UNITED STATES
NUCLEAR REGULATORY COMMISSION
ADVISORY COMMITTEE ON REACTOR SAFEGUARDS
WASHINGTON, D.C. 20555-0001

SUBJECT: SUMMARY REPORT - 478TH MEETING OF THE ADVISORY COMMITTEE ON REACTOR SAFEGUARDS, ON DECEMBER 6-9, 2000, AND OTHER RELATED ACTIVITIES OF THE COMMITTEE

FIGURE 4

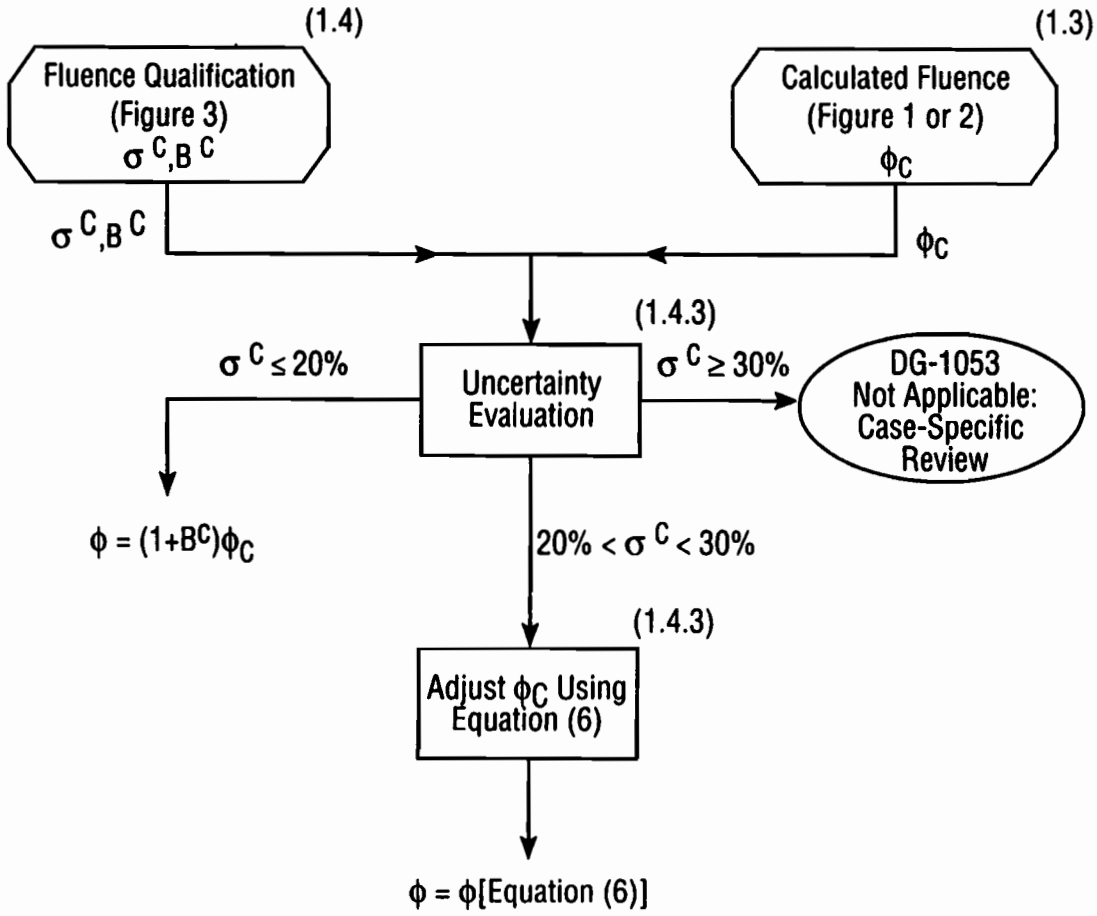
RESPONSES TO THE COMMENTS PROVIDED BY BECHTEL POWER CORP. William C. Hopkins	
Comments	**Responses**
2) Comment: The attached figure should be included in the Guide to clarify the dependence of the fluence determination on the fluence uncertainty.	2) Response: The proposed figure provides a significant clarification of the procedure used to determine the fluence and will be included (as Figure-4) in the Guide.
